DART+ West Project
Section B: M50 to Barberstown

Stage 1 Road Safety Audit

Document Ref:	P22-021-PSW2-RP-001
----------------------	----------------------------

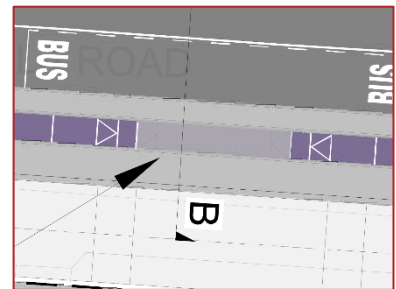
Summary: Potential for cyclist-pedestrian collisions and slips, trips, and falls where bus passengers are required to cross the cycle track when boarding or disembarking buses throughout the Scheme.

Bus stops have been indicated on some arms of the Castleknock Road and Clonsilla Road Junctions and at the Clonsilla Level Crossing. The road layout at the bus stops requires passengers boarding or disembarking the bus to cross the cycle track to access the bus stop/footpath. The segregated cycle track is indicated as being continuous through bus stop locations at both junctions while at the Clonsilla Level Crossing the cycle track is terminated either side of the bus stop to permit access to/from the bus.

Pedestrians, particularly the visually and mobility impaired, may be unable to safely access the bus stop resulting in an increased risk of being struck by a cyclist, or trips and falls at the vertical separation between the footway and cycle track.

Where a link between the footpath and bus stop has been indicated (Clonsilla Level Crossing), tactile paving has not been indicated at the cycle track terminations which may lead to visually impaired pedestrians inadvertently accessing the cycle track and being struck by a cyclist.

The segregated cycle track should transition to a shared use footpath upstream of bus stop locations. Ladder and tramline tactile paving, as well as relevant signage, should be provided at the transitions between the cycle track and shared use footpath.

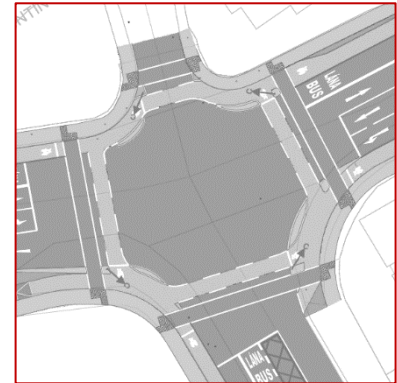
Note, the use of uncontrolled crossings between the footpath and island bus stop may not support visually impaired pedestrians, as they will be unable to locate the tactile paving when disembarking the bus.

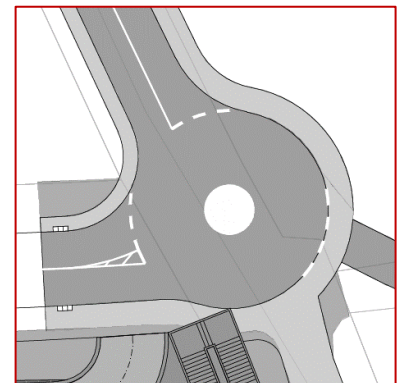
Summary: Swept paths at proposed signalised junctions have not been provided to the Audit Team and it is therefore unclear if all vehicles can safely complete turning manoeuvres within the extents of their traffic lane.

Information regarding swept path analysis has not been provided to the Audit Team. As the proposed junction upgrades include the introduction of physical islands within the junction layout, the width of the carriageway will be reduced in places. It is therefore unclear if HGVs and buses will be able to complete turning manoeuvres within the carriageway extents. If turning manoeuvres cannot be undertaken within the extents of the traffic lane there is a risk of kerb strikes, collisions with other road users or collisions with items of roadside furniture.

Ensure the swept path of all vehicles can be accommodated safely at all upgraded junctions.

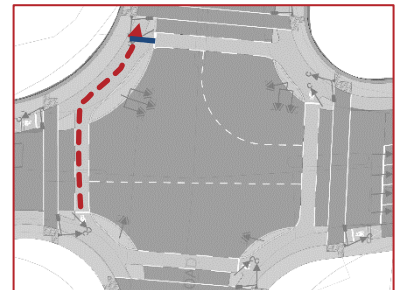
Summary: Traffic signal information has not been provided to the Audit Team.

Given the project's early design stage, traffic signal phasing details have not been provided for the proposed upgraded junctions, including the Castleknock Road Junction, Clonsilla Road Junction, Diswellstown Road Junction and Porterstown Road Junction. It is therefore unclear what movements will be permitted during each signal phase and whether cyclist movements will be segregated or occur during a phase with motorised vehicles where the risk of conflicts would be increased.

Also, the pedestrian crossings at the junctions are relatively long and it is also unclear if sufficient time will be provided during pedestrian phases to allow all pedestrians to complete a crossing during a single phase. Refuge islands have not been provided at crossings and should a pedestrian be unable to complete a crossing during a pedestrian phase there is an increased risk of them being struck by a vehicle.

Ensure opposing manoeuvres do not occur during the same phase and that sufficient time is provided during pedestrian phases to allow all pedestrians, including mobility impaired pedestrians, to complete a crossing during the phase.

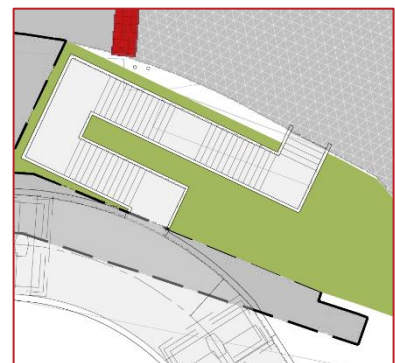
Summary: Right-turning cyclists may block straight through cyclists at signalised junctions.

Protected cycle lanes are indicated at a number of signalised junctions within the Scheme. However, it is unclear from the drawing if there will be sufficient space at stop lines to allow cyclists to wait outside the path of an adjacent cyclist. Should there be insufficient space for a cyclist to pass a stationary cyclist, there is a risk of collisions between cyclists or to cyclists entering the carriageway, to pass a stationary cyclist, at locations where drivers may be less attentive to a cyclist entering the carriageway increasing the risk of collisions.

Ensure sufficient space is provided at cyclist stop lines for a stationary cyclist to wait out of the path of an oncoming cyclist.

Location: Drawings no. MAY-MDC-HRW-LC04-DR-C-0101 (Rev. V01)

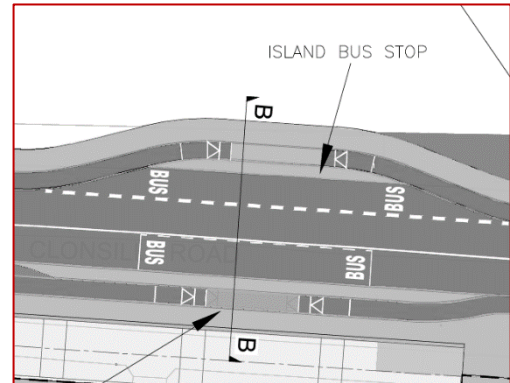
Summary: Insufficient effective width at island bus stop.

Island bus stops are indicated on both sides of the Clonsilla Road. It is unclear what the effective width of the footpath will be at the island bus stops, although they appear to be relatively narrow on the drawings provided. Should the islands be too narrow to accommodate waiting pedestrians there is a risk of pedestrians waiting for a bus within the path of cyclists where there is an increased risk of being struck by a cyclist.

This could be exacerbated during peak times when large volumes of pedestrians are likely to congregate while waiting for a bus.

As per the Recommendation in Problem 3.1.1, a shared use footpath should be provided at bus stops within the Scheme. Also, ensure the shared use footpath at this bus stop is of a sufficient width to accommodate waiting pedestrians such that they will not encroach into the path of cyclists.

Location: Drawings no. MAY-MDC-HRW-LC04-DR-C-0101 (Rev. V01)

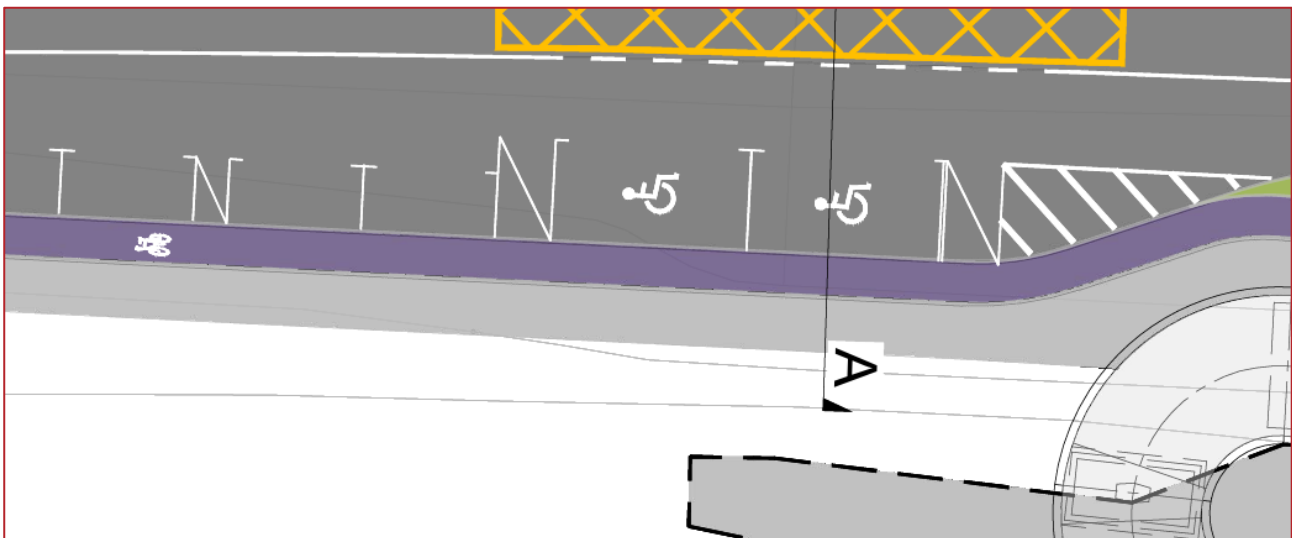
Summary: No safe access route to footpath from parking spaces.

Parking spaces have been indicated on the southern side of Clonsilla Road, including two mobility impaired parking spaces. To access the adjacent footpath, drivers/passengers would be required to cross the cycle track where no crossing has been indicated. A lack of a formal crossing may lead to an increased risk of pedestrians being struck by a cyclist when travelling between the parking spaces and footpath.

Also, it is assumed that there will be a kerb at the edge of the carriageway adjacent the parking spaces. A lack of a dropped kerb may present accessibility issues for mobility impaired pedestrians when accessing the footpath.

A safe pedestrian route from the parking spaces to the footpath should be provided.

Additionally, a dropped kerb, and tactile paving, should be provided adjacent the mobility parking spaces to allow mobility impaired users access the footpath.

Location: Drawing no. MAY-MDC-HRW-LC02-DR-C-0188 (Rev. V01)

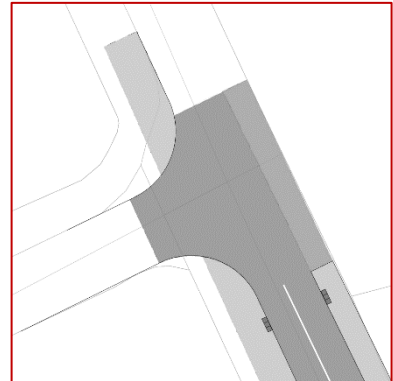
Summary: Left-turning drivers may be insufficiently aware of straight-ahead cyclists on their nearside prior to entering the left turn lane approaching the Porterstown Road junction.

On the southbound approach to the Porterstown Road junction the cycleway is indicated between the straight-ahead and left-turn traffic lanes.

Left-turning drivers, approaching the junction in the through traffic lane may be insufficiently aware of a cyclist approaching on their nearside as the existing cycle facilities upstream are off-road. This may lead to drivers failing to take due care and consideration of cyclists approaching from the footway when changing lane, increasing the risk of vehicle-cyclist collisions.

If the expected traffic volumes do not require two lanes, the existing layout with only a single lane should be retained.

Alternatively, the off-road cycle track should transition to the carriageway in greater advance upstream of the left-turn lane development to increase a driver's awareness of cyclists on the carriageway. The weaving area

Location: Drawing no. MAY-MDC-HRW-LC03-DR-C-0100 (Rev. V01)

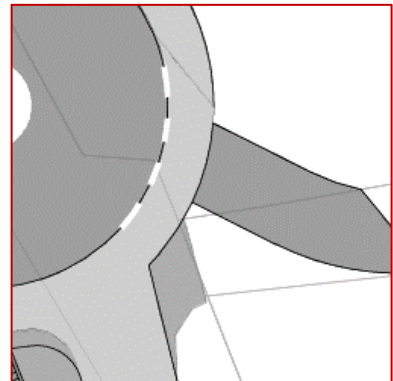
Summary: Absence of pedestrian crossing across ‘The Village’ side road.

A formal pedestrian crossing point has not been indicated, nor is one currently provided, across ‘The Village’ side road, at the northern extents of the scheme. A failure to provide a formal crossing point could lead to visually, and mobility, impaired pedestrians being unable to safely and independently cross to the opposite footpath. This could result in slips, trips, or falls as these pedestrians attempt to descend the kerb, or an increased risk in visually impaired pedestrians unintentionally entering the carriageway where they could be struck by a vehicle.

An uncontrolled pedestrian crossing, including dropped kerbs and tactile paving, should be provided across ‘The Village’ side road at its junction with Porterstown Road.

Location: Drawing no. MAY-MDC-HRW-LC02-DR-C-0188 (Rev. V01)

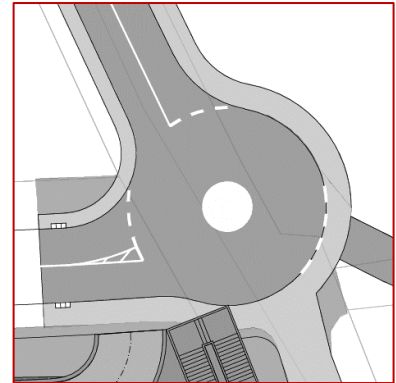
Summary: Insufficient lateral clearance between the footbridge and the roundabout circulating carriageway.

The corner of the footbridge indicated at the Porterstown level crossing is located in close proximity to the roundabout circulating carriageway where it is at risk of being struck by high-sided vehicles resulting in potential structural damage to the footbridge.

Ensure the steps of the footbridge are sufficiently offset from the circulating carriageway, such that high-sided vehicles, or errant drivers, are unable to conflict with the structure.

Location: Drawing no. MAY-MDC-HRW-LC02-DR-C-0100 (Rev. V01)

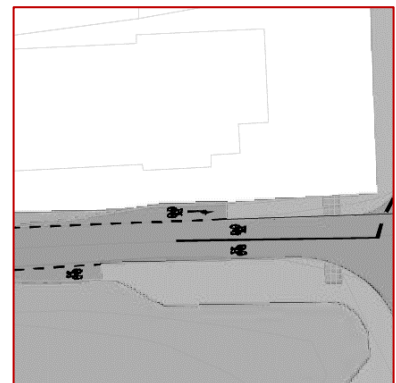
Summary: Effective width of shared surface may be insufficient to accommodate both pedestrians and cyclists.

Cyclists are directed off the Sheepmore Lane carriageway towards an uncontrolled pedestrian crossing to access the pedestrian and cycle bridge at the Coolmine level crossing. The short section of footpath between the cycle ramp and uncontrolled pedestrian crossing will effectively operate as a shared surface for pedestrians and cyclists. It is unclear if the width of this section of footpath is sufficient to accommodate both cyclists and pedestrians. Should the shared surface be incapable of accommodating pedestrians and cyclists, there is an increased risk of pedestrian-cyclist collisions.

The width of the shared surface should be sufficient to accommodate pedestrians and cyclists.

Location: Drawing no. MAY-MDC-HRW-LC02-DR-C-0100 (Rev. V01)

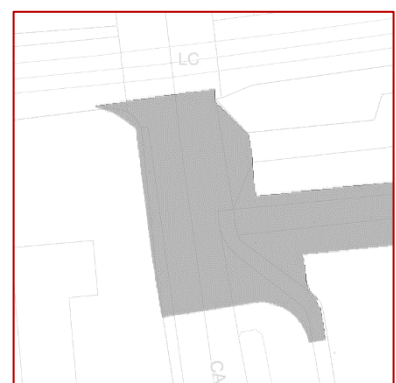
Summary: It is unclear how the carriageway will be terminated on the southern side of the Coolmine level crossing.

It is proposed to terminate Carpenterstown Road on both sides of the Coolmine level crossing. While a roundabout has been indicated on the northern side of the crossing it is unclear how the carriageway on the southern side will be terminated. If the end of the carriageway is not sufficiently defined drivers approaching the crossing may be insufficiently aware that there is no through route, particularly during the hours of darkness, resulting in an increased risk of overshoot type incidents and collisions with items of roadside furniture or the boundary/gates at the railway line.

The road layout on the southern side of the level crossing should be clearly defined such that drivers are aware of the carriageway termination.

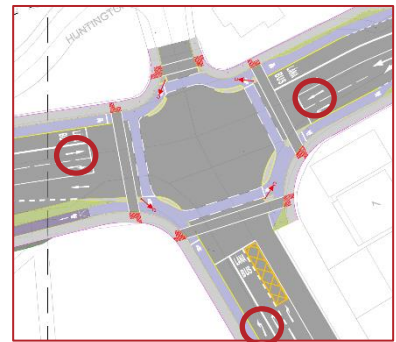
- 4.3 Arrow road markings for movements into Huntington Lodge have not been indicated within the traffic lanes on the approaches to the Castleknock Road Junction. Whilst it is likely that entry and exit manoeuvres into this small residential development will be infrequent these movements are not prohibited at the junction. The following measures should be provided: -

- Western arm: A straight-ahead and left-turn arrow in lieu of the straight-ahead only arrow indicated.
- Southern arm: A straight-ahead and left-turn arrow in lieu of the left-turn only arrow indicated.
- Eastern arm: A straight-ahead and right-turn arrow in lieu of the straight-ahead only arrow indicated.

Additionally, the signal phasing should be reviewed to ensure these movements do not lead to conflicts with other streams of traffic.

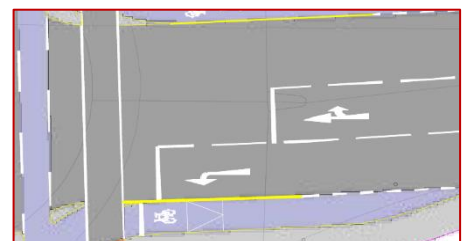
- 4.4 The stop line in the straight-ahead and right-turn lane on the eastern arm of the Clonsilla Road junction is set back presumably to allow for buses turning left into this arm. A Yellow box should be provided on the carriageway between the stop line and the crossing to ensure drivers do not mistakenly overshoot the stop line and obstruct the swept path of incoming large vehicles.

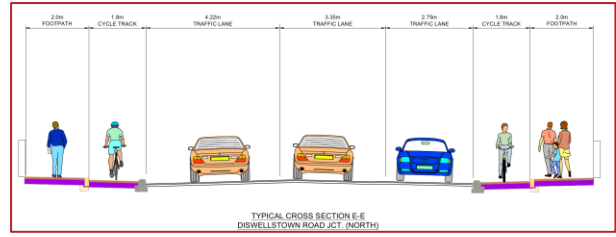
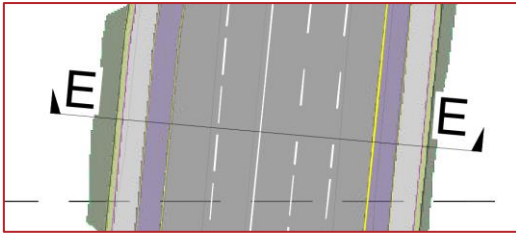
- 4.5 Cross sections D-D, E-E, and F-F for the Diswellstown Road Junction do not sufficiently convey the proposed road layout with the incorrect number of traffic lanes indicated. The drawings should be amended to ensure consistency with the plan drawings and to prevent confusion during construction.

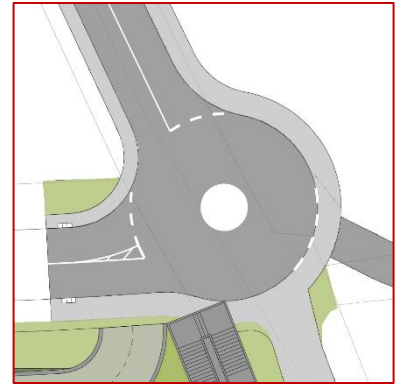
4.7 Junction control has not been indicated at the proposed roundabout on the northern side of the Porterstown level crossing. Yield road markings should be provided at the entrance to the roundabout circulating carriageway on all arms to clearly advise drivers of the priority at the roundabout.
